Work Order ID 67075

Item Name: 205 Skidtube bent detail

DRAWING NO. D2580	TITLE 205 SKIDTUBE ASSEMBLY	REV. D	DART AEROSPACE LTD ENGINEERING ORDER		D.E.O. NO. D2580-D-1	SHEET NO. SHEET 1 OF 1	SCALE NTS
DRAWN <i>UP</i>	CHECKED <i>L</i>	MFG. APPR. <i>E</i>	APPROVED <i>MP</i>		DE APPR. <i>H</i>		
DATE 10.09.22	DATE 10.11.04	DATE 10.11.04	DATE 10/11/04		DATE 10.11.04

CHANGE ALL WELDED CROSSBOLT SPACERS TO SWAGED SPACERS

SECTION D-D & SECTION H-H ARE AMENDED AS FOLLOWS:

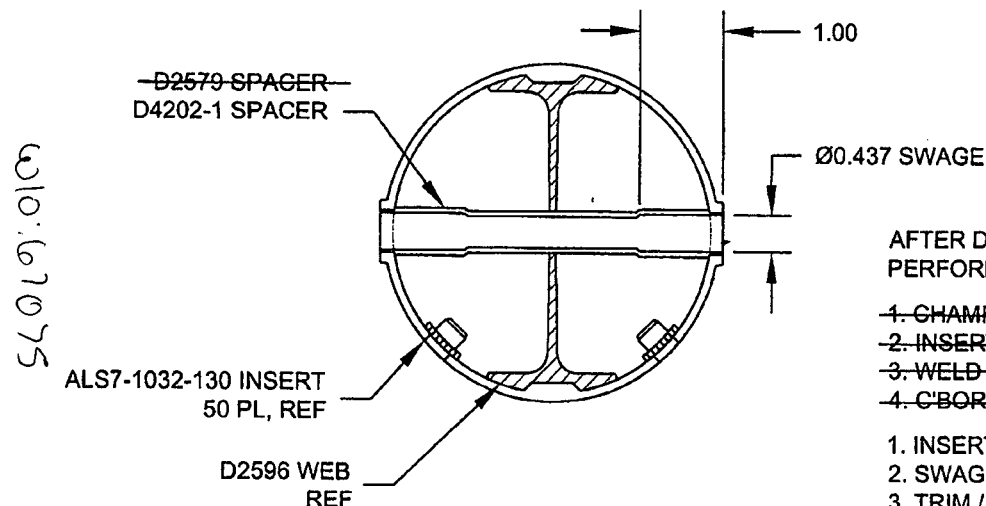
WAS

QTY	QTY	PART NUMBER	DESCRIPTION
-041	-045		
20	24	D2579	CROSS BOLT SPACER

AFTER DRILLING AND BENDING ASSEMBLY
PERFORM THE FOLLOWING FOR Ø0.508 HOLES ONLY:

1. CHAMFER HOLE 0.050 X 45°
2. INSERT D2579 SPACER (20 PLACES)
3. WELD INTO PLACE AND GRIND FLUSH
4. C-BORE D2579 SPACER TO Ø0.437 X 1.00 DEEP

IS

20	24	D4202-1	SPACER
----	----	---------	--------

1. INSERT D4202-1 SPACER, 20 PL (-041) OR 24 PL (-045)
2. SWAGE TO Ø0.437 X 1.00 DEEP PER QSI 002
3. TRIM / GRIND FLUSH PER QSI 002
